**MEETING OF THE
PLANNING AND ZONING BOARD
QUASI-JUDICIAL PUBLIC HEARING**

May 21, 2019

**TOWN OF BAY HARBOR ISLANDS
DRC STAFF
PLAN REVIEW**

**RE: BELIZA 1170 102 STREET
RESPONSE TO COMMENTS BY MICHAEL MILLER PLANNING ASSOCIATES, INC.**

LEVEL TWO FLOOR PLAN [6,600 SF]

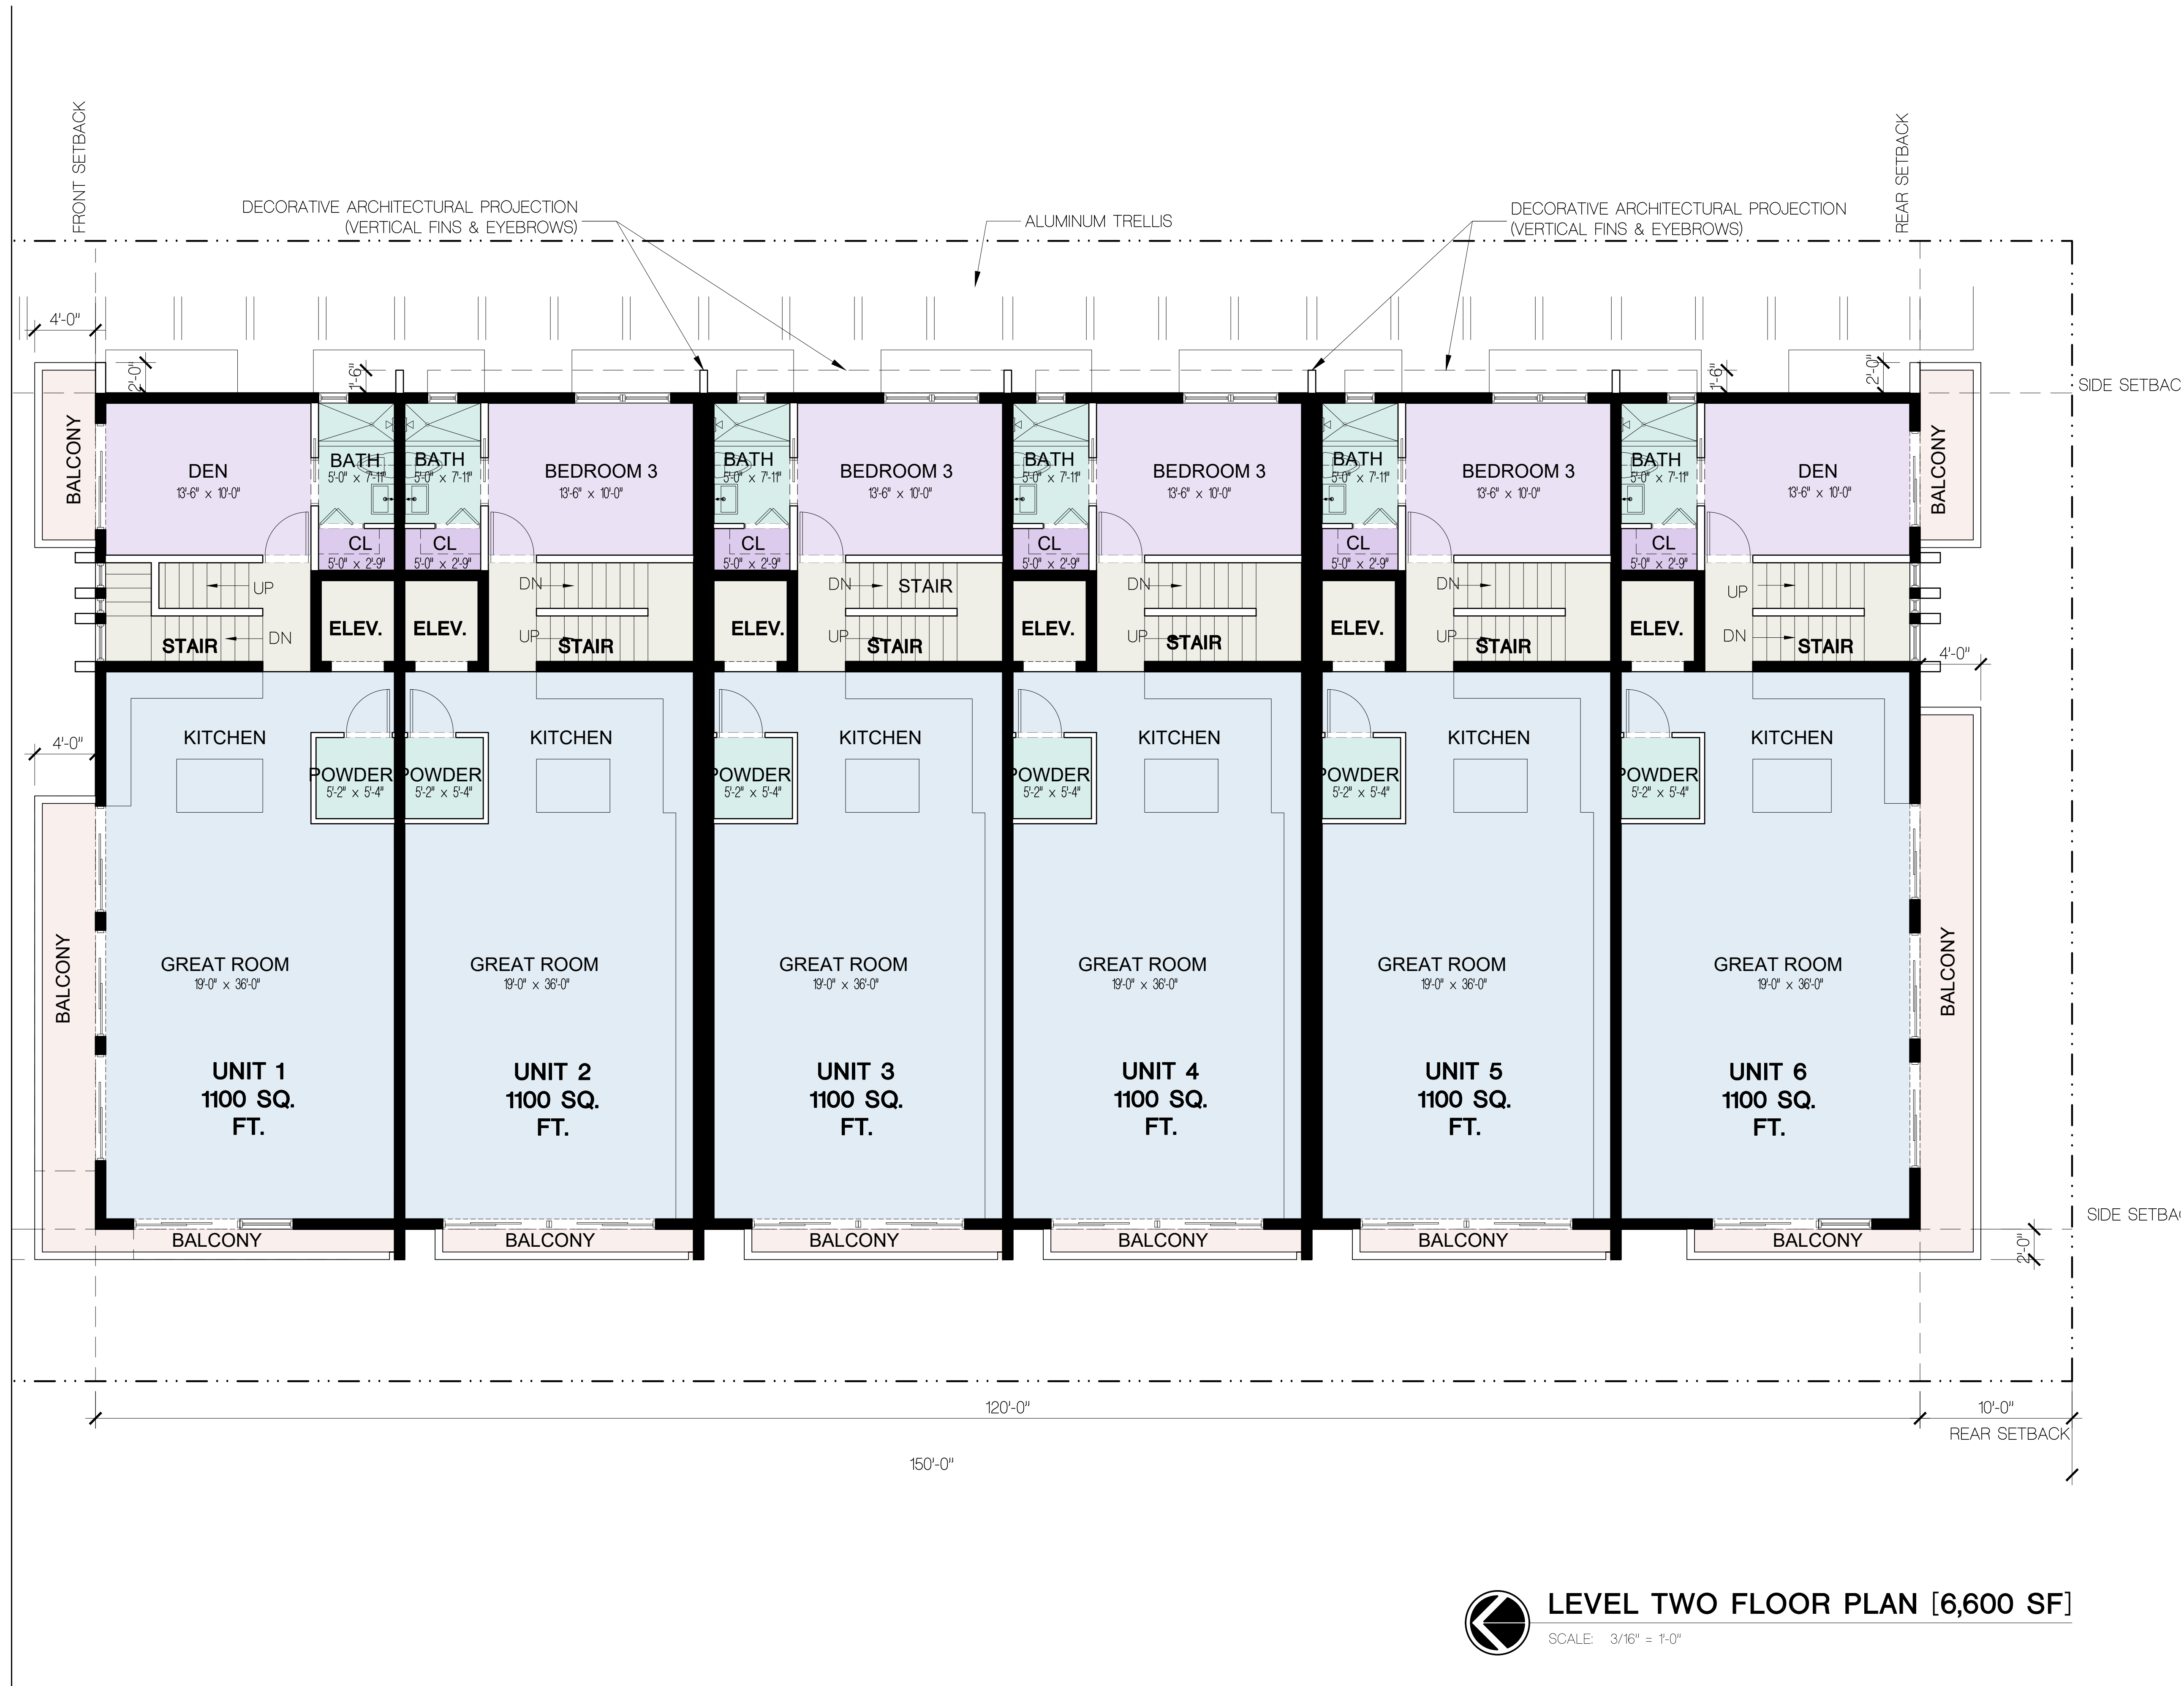
SHEET A-1.02 HAS DRAFTING ERRORS THAT NEED TO BE CORRECTED PURSUANT TO OUR CONVERSATION WITH THE ARCHITECT; WINDOWS AND SLIDING GLASS DOORS ARE MISSING ON THE END UNITS BUT ARE SHOWN ON THE ELEVATIONS.

Please refer to the revised Sheet A-1.02 with the added Sliding Glass Doors.

SOUTH ELEVATION

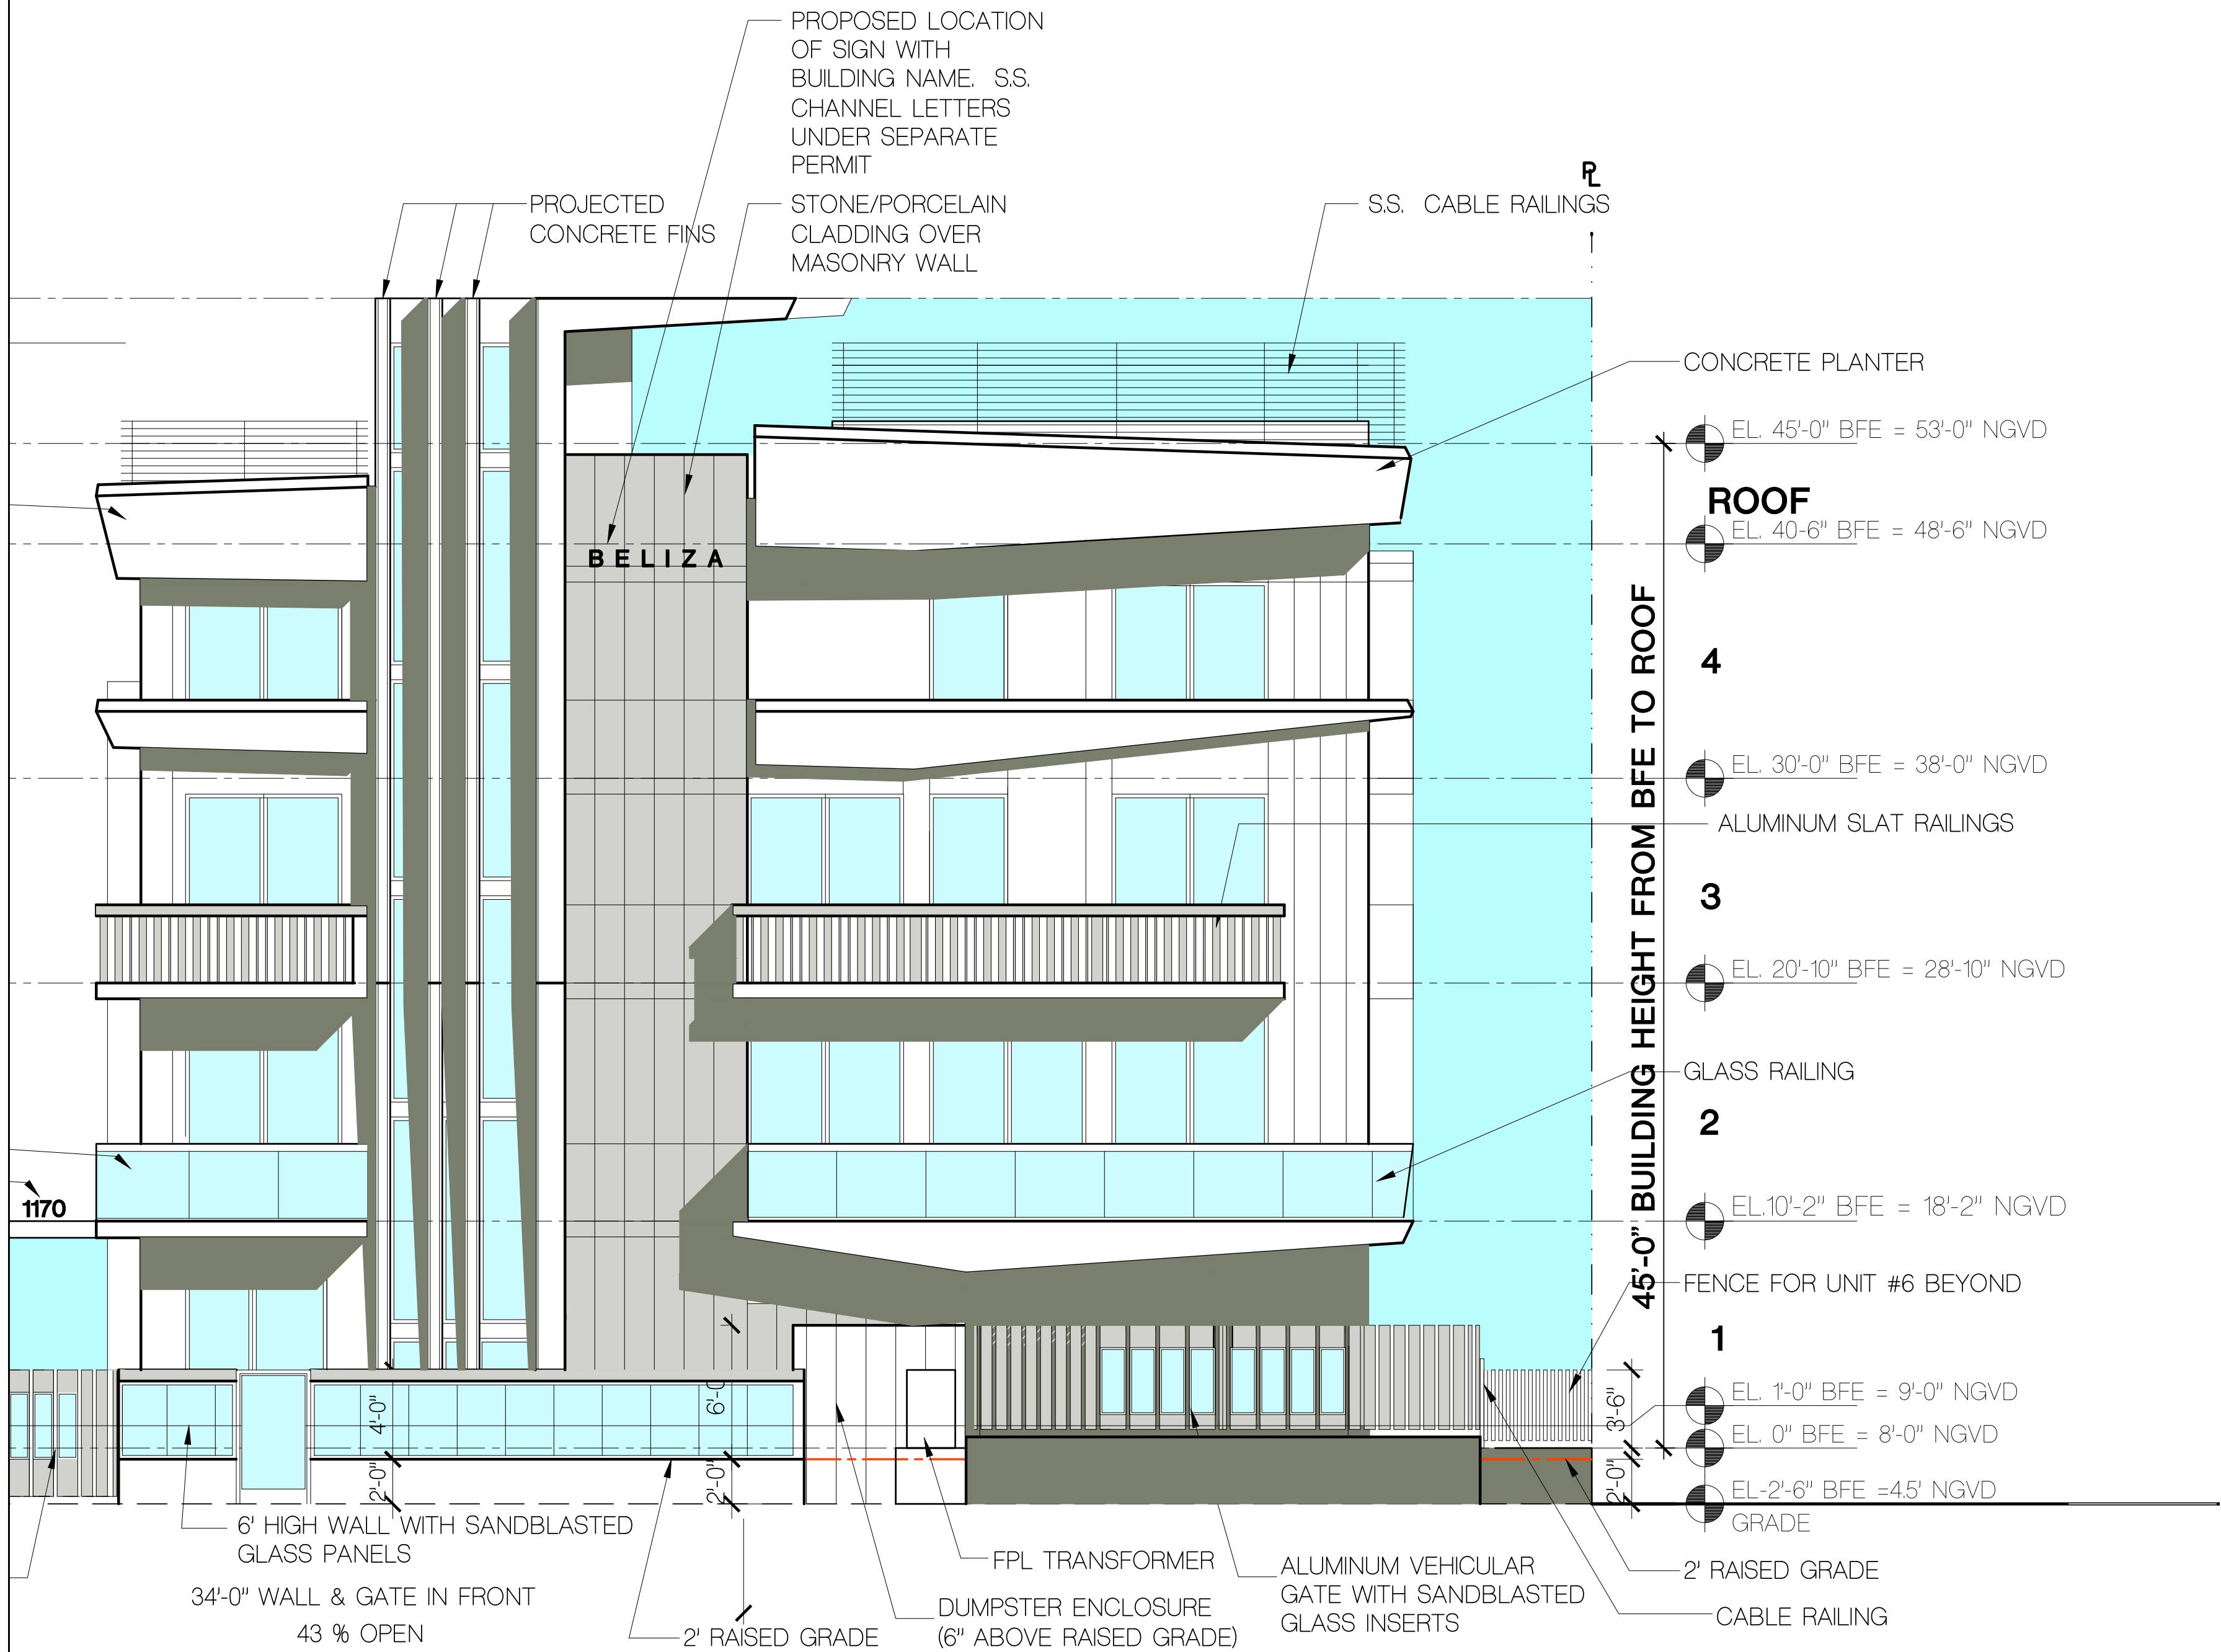
PROVIDE FUTURE SIGN LOCATIONS (BUILDING/ADDRESS). THIS SHOULD BE STUDIED NOW, AND TENTATIVE LOCATIONS NOTED. AFTERWARD IT IS SOMETIMES DIFFICULT TO FIND AN APPROPRIATE SURFACE.

Please refer to the revised Sheet A-2.01 for the proposed location of the Building Name and Address.
